Primary Engineering, Inc.
2828 Lake Ave.
Fort Wayne, Indiana 46805
260-424-0444 ph
www.primary-eng.com

Addendum: **1**
Date: **3/7/2025**
Project: **FWCS HPB Natatorium HVAC Improvements**

Comm #: **24634**

SHEET:
M303

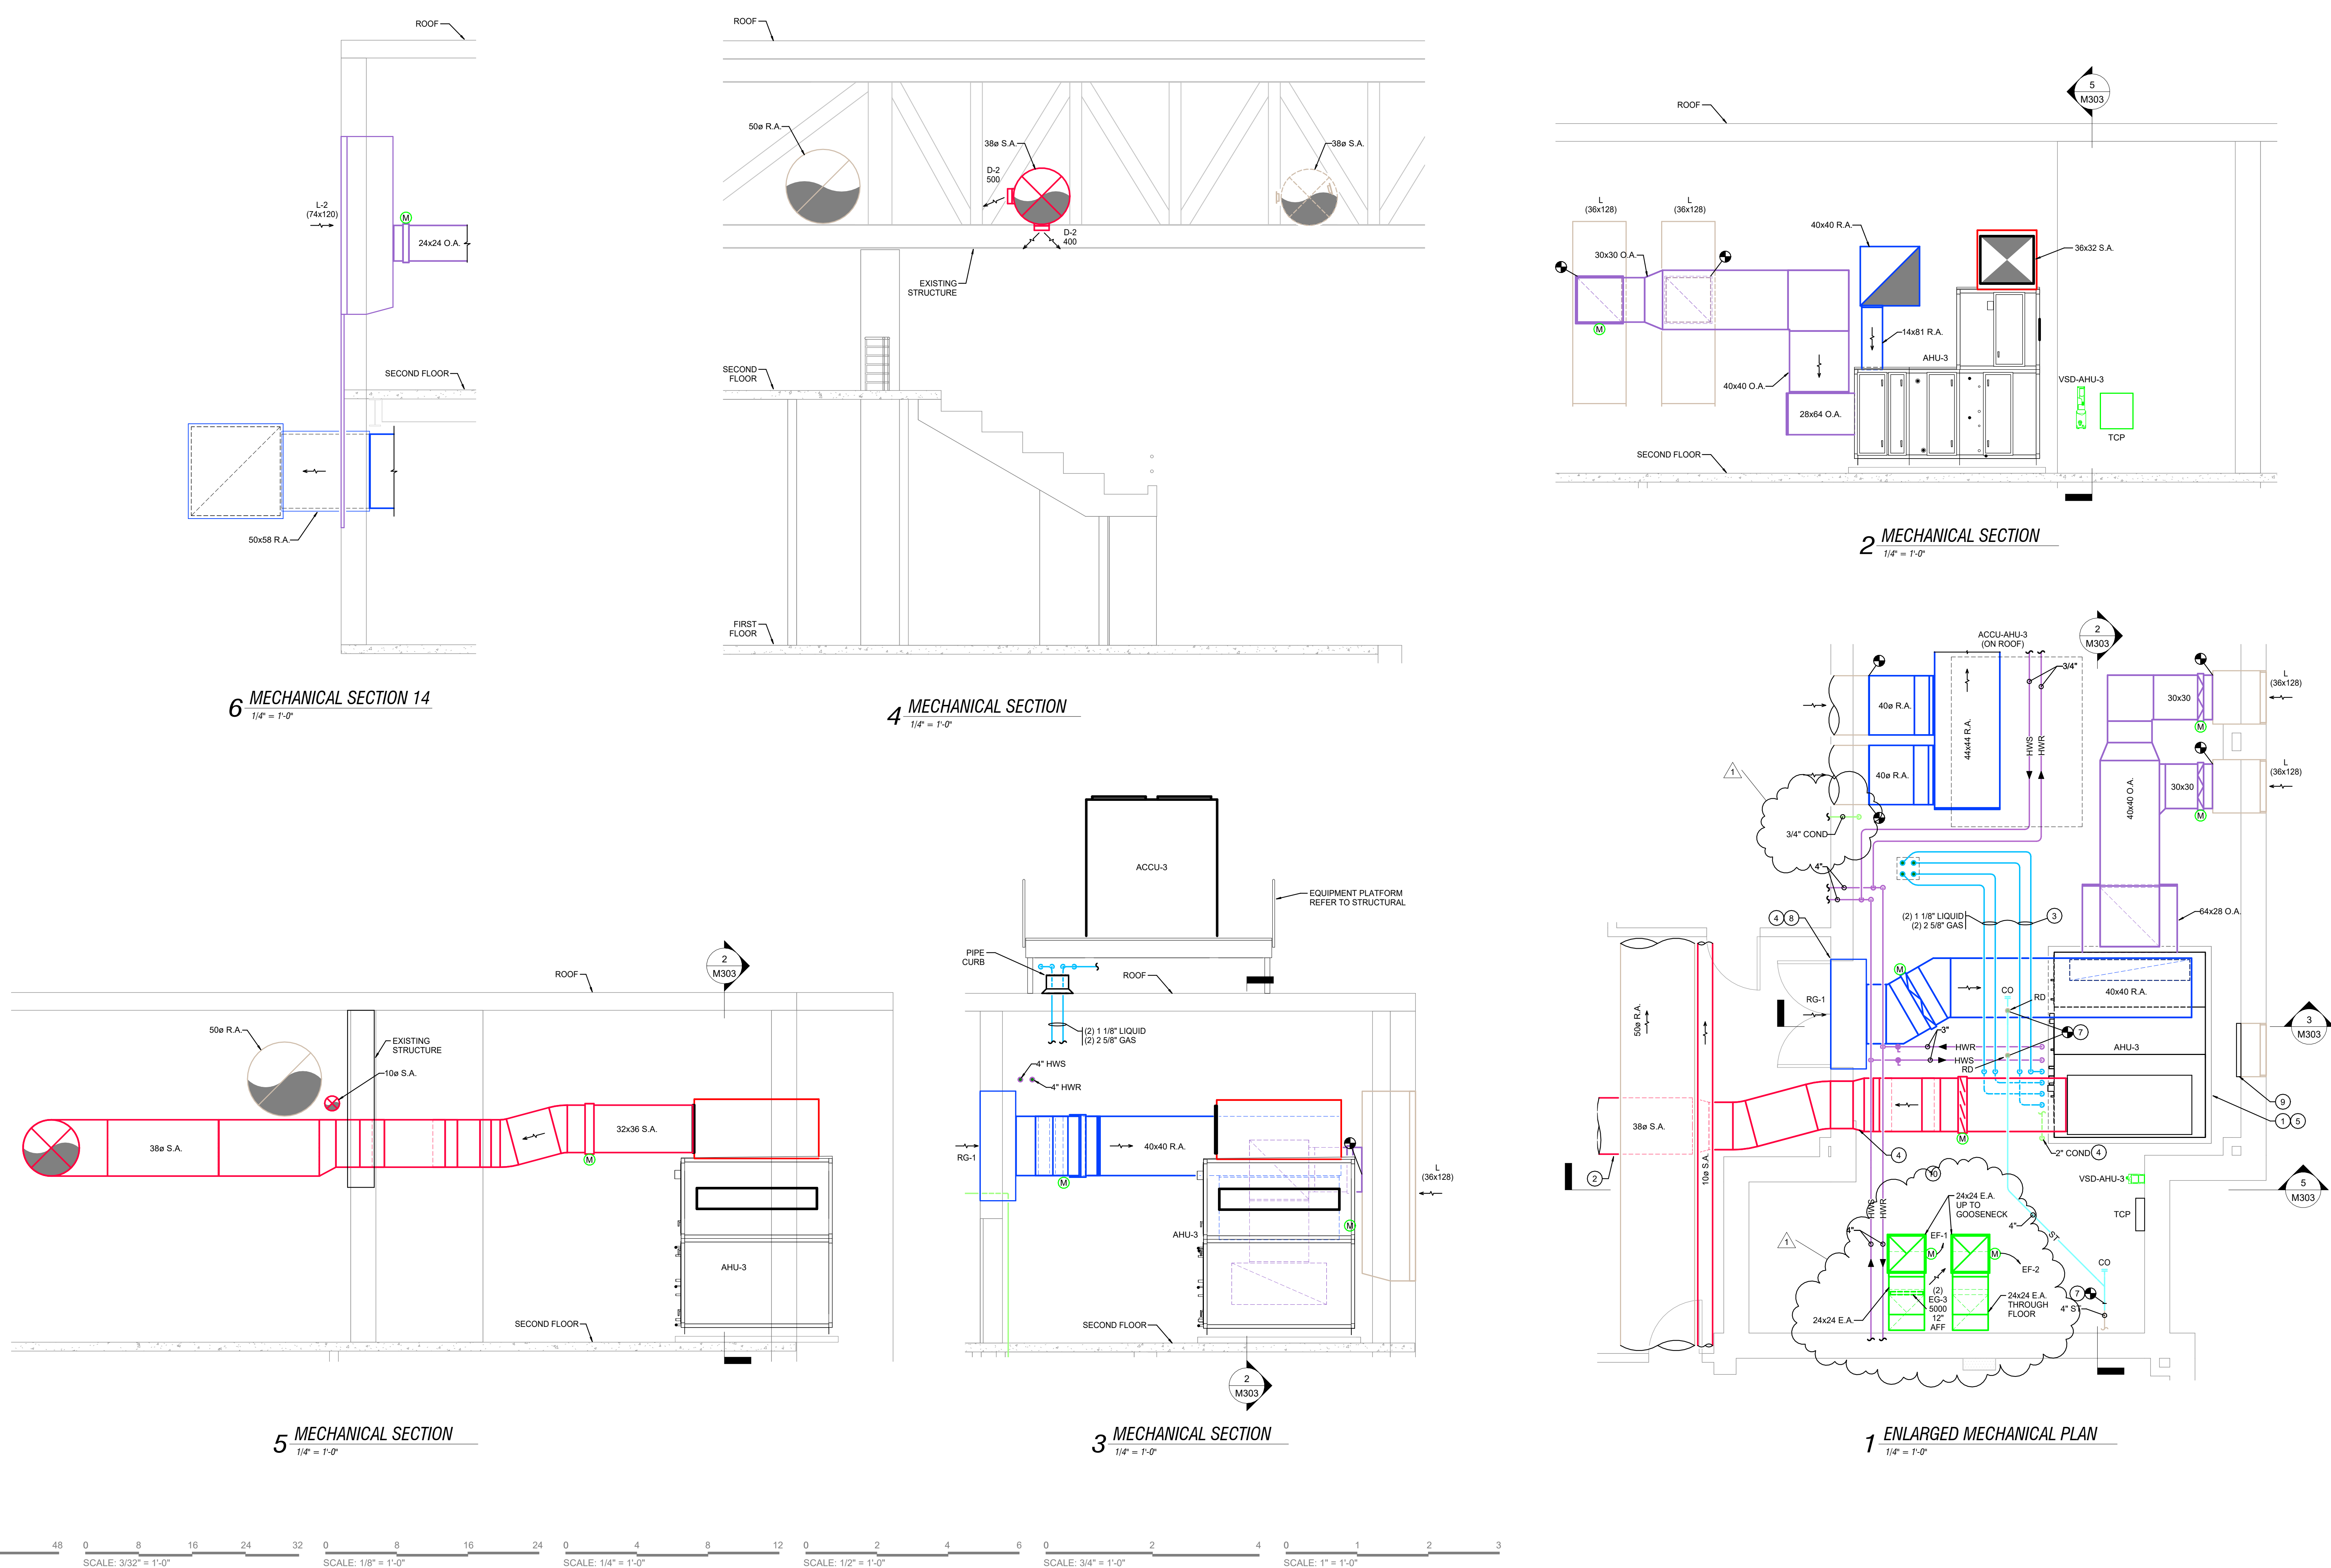
- A. Add refrigerant monitoring and exhaust systems. Add condensate piping to HVAC-1. See attached drawing revision to M303 dated 3/7/2025.
